Areas of Specific Concern in the NIST WTC Reports

Below is a series of twenty-five provable points which clearly demonstrate that the reports produced by the National Institute of Standards and Technology (NIST) on the destruction of the World Trade Center (WTC) were unscientific and fraudulent. Therefore NIST itself – including its lead authors, Shyam Sunder and John Gross - should be investigated.

Figure 4-62. Exterior buckling after global collapse initiation.

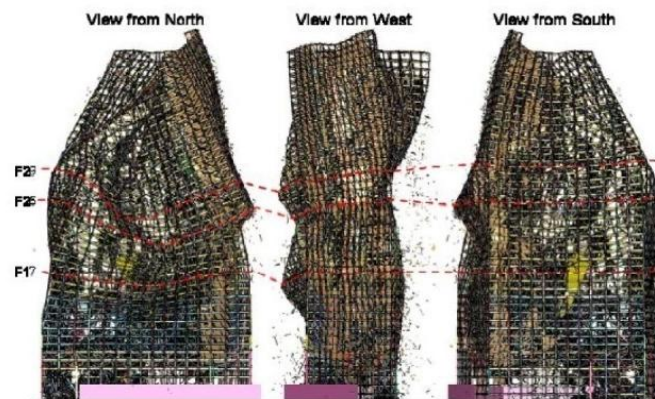
Technical Statement: The exterior of the NIST WTC 7 computer model shows large deformations, as would be expected in a natural collapse, which are not observed in the video of the actual event. There is no attempt in the report to explain this discrepancy.

In footage of the actual collapse, the west penthouse of WTC 7, which spans nearly half the length of the roof, starts to fall one-half of a second prior to the full exterior collapse, yet the NIST report claims that the entire interior failed and completely collapsed prior to the exterior shell collapsing. Since there was little-to-no visible deformation of the exterior in the actual collapse and since the west penthouse collapse timing indicates near-simultaneous interior and exterior failure, it seems clear that the severe deformation of the building’s exterior in the NIST model shows that their model does not replicate the actual

collapse situation at all. The west penthouse drop starting just prior to that of the exterior is also indicative of controlled demolition, where the interior columns are severed just a fraction of a second prior to the exterior, in order to create an inward pull on the exterior and keep the debris contained within the building's footprint.

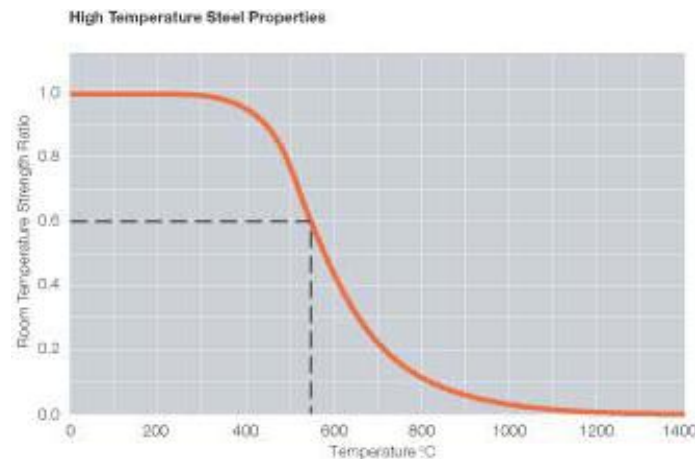
Technical Statement: NIST claims that the aircraft impact debris in WTC 1 stripped the fireproofing materials from the floor truss assemblies — even on the opposite side of the building from the impact — to the point where the floor assembly steel was then vulnerable to fire. NIST attempted to validate this hypothesis with ballistic firing equipment, firing buckshot and shrapnel at steel plates and bars coated with SFRM (Sprayed on Fire Resistant Material). During the testing, the gun was fired at velocities of approximately 500 ft/s and produced damage to the SFRM, but at one point it misfired and produced a projectile velocity of just 102 ft/s (31 m/s), which resulted in no damage to the SFRM.

WTC 1 was impacted on the north side of the building. NIST claims that the fireproofing was stripped from the trusses on the south side, causing them to sag and pull the south face of the building inward, initiating the collapse. However, NIST's own analysis of the aircraft's deceleration, 0.40 seconds after impacting WTC 1 on the north face, shows the debris field moving at approximately 51 ft/s (15 m/s) as it enters the floor assembly area on the south side of the building. How can NIST justify the aircraft debris damaging the SFRM on the floor assembly steel on the south side of the building when their own testing and analyses seem to rule it out?

- Two velocity charts below

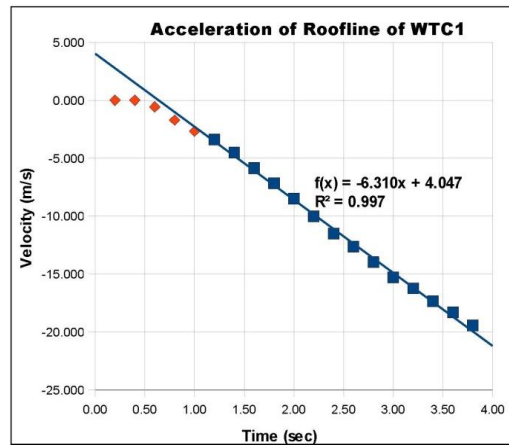
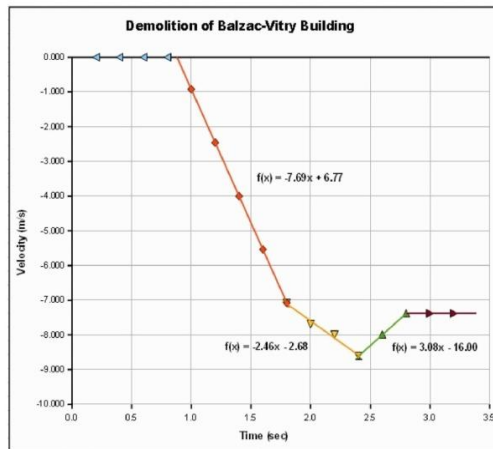
The velocity graphs of the upper sections of both a building demolished by the Verinage technique and that of WTC 1 are shown below. Note the abrupt reduction of velocity in the *natural* force collapse using the Verinage demolition method on the Balzac-Vitry building in France vs the *continuous* acceleration of WTC 1. The columns in WTC 1 must have been “removed” prior to impact. This can only be done by explosives — for which there is abundant evidence, as outlined in the documentary film, *9/11: Explosive Evidence—Experts Speak Out*.
